ARC-24-0085 (ZON-24-0044)

New Residence at:
315 Chapel Hill Road

FINAL SUBMITTAL

SUMMARY OF COMMENTS

ITEM 1

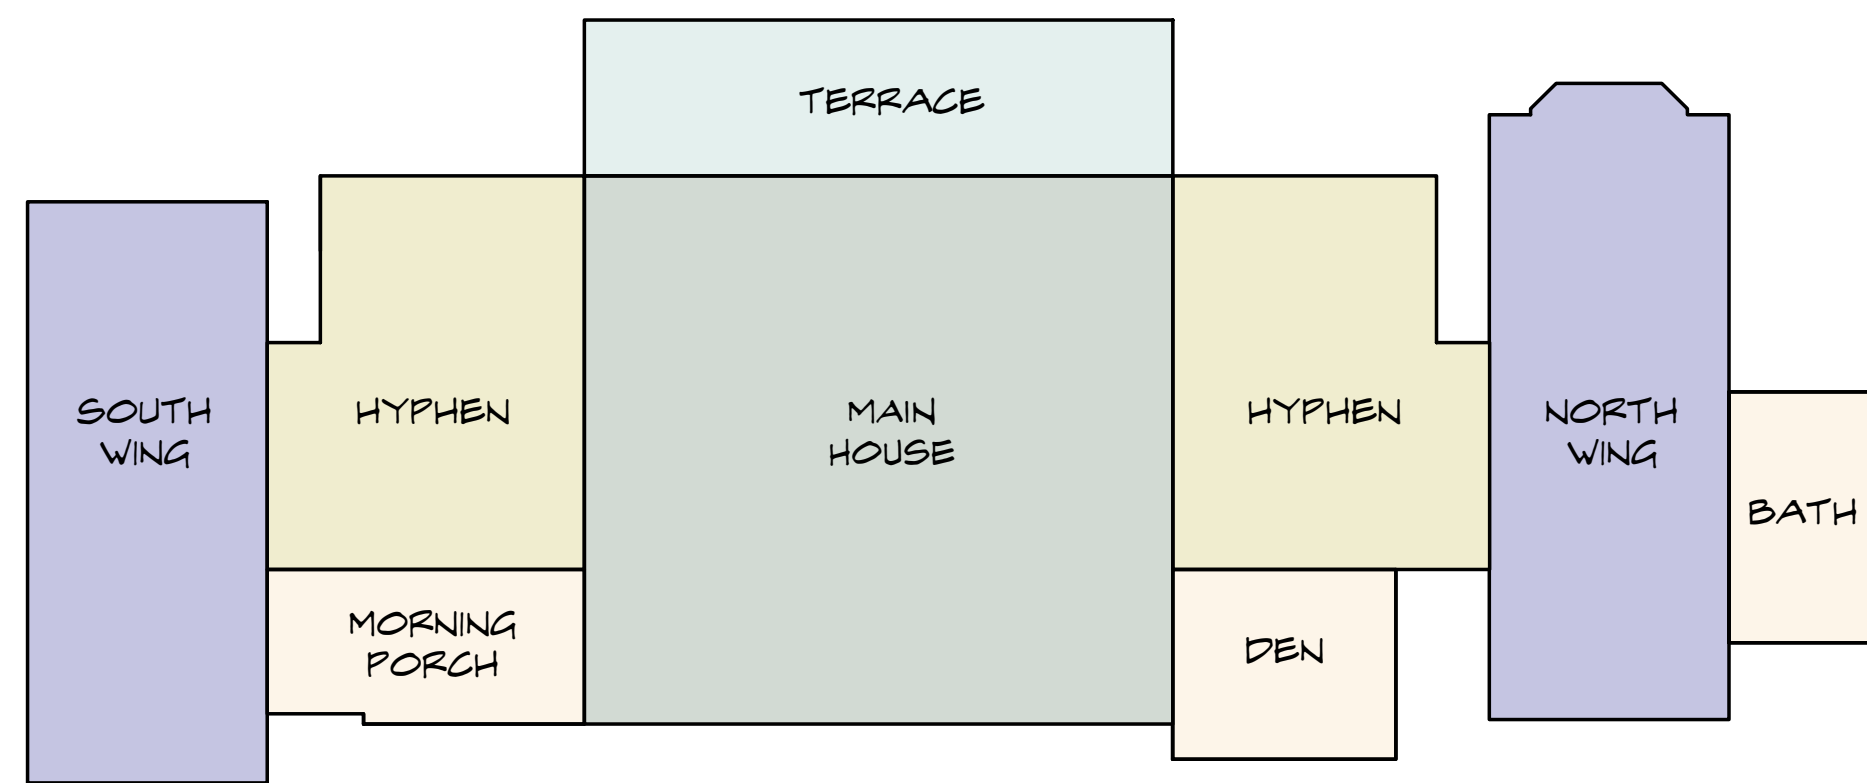
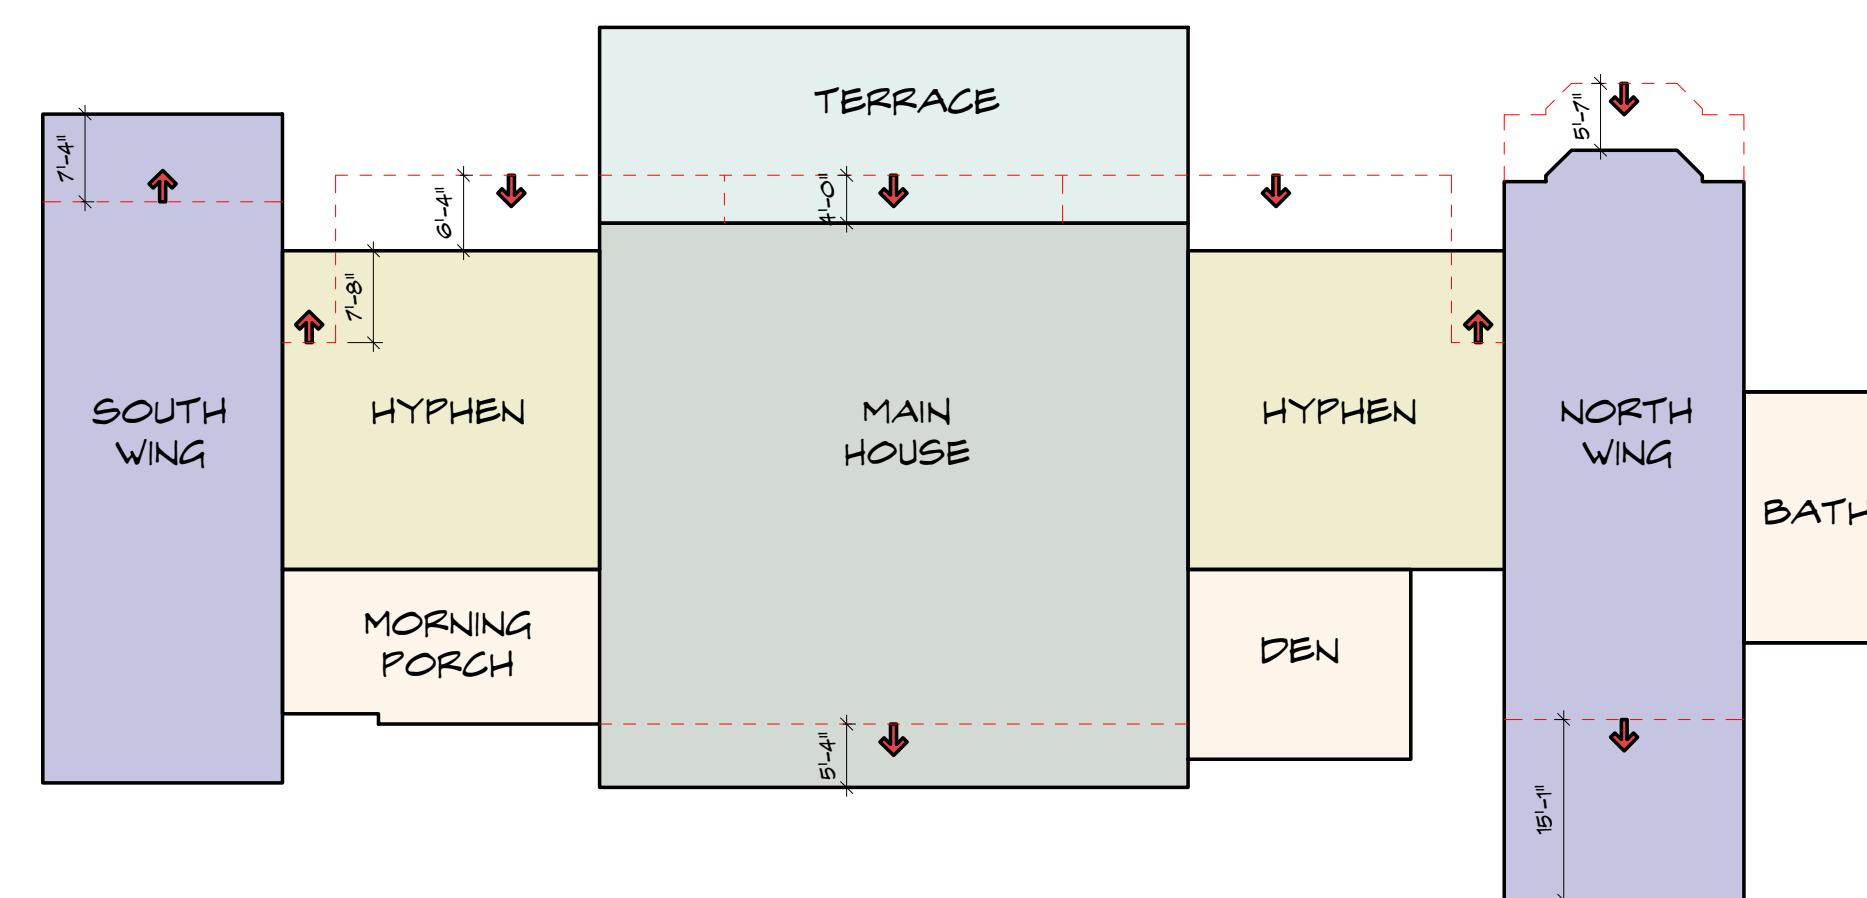
PARTI/MASSING - BETTER DEFINE HYPHENS

RESPONSE: ADJUSTED MASSING (SEE BELOW)

ITEM 2

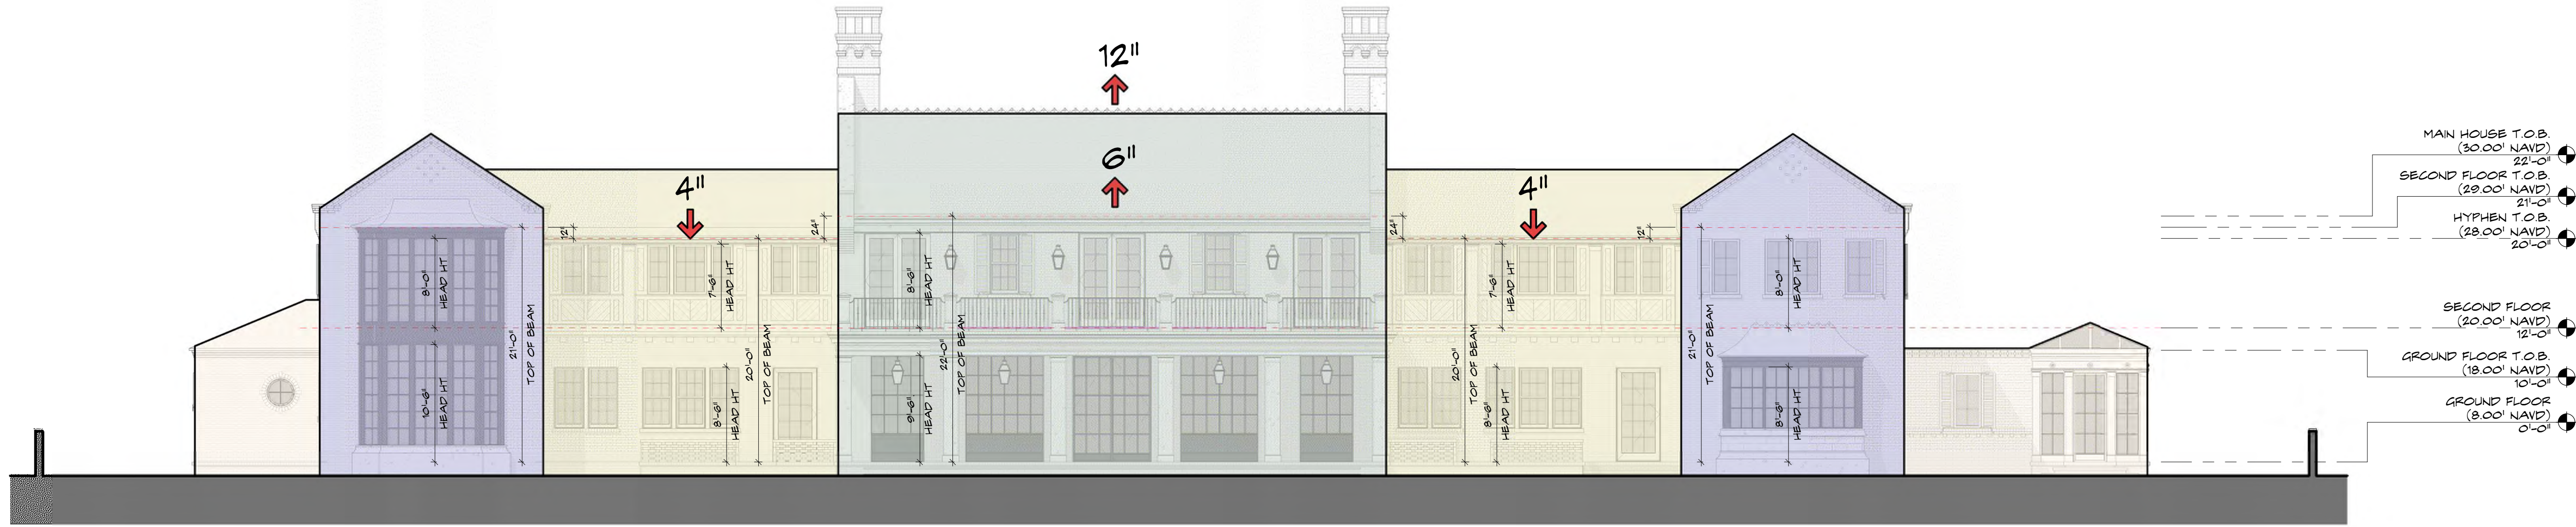
PARTI/MASSING - VERTICAL HIERARCHY

RESPONSE: ADJUSTED EAVE / WINDOW HEAD HEIGHTS
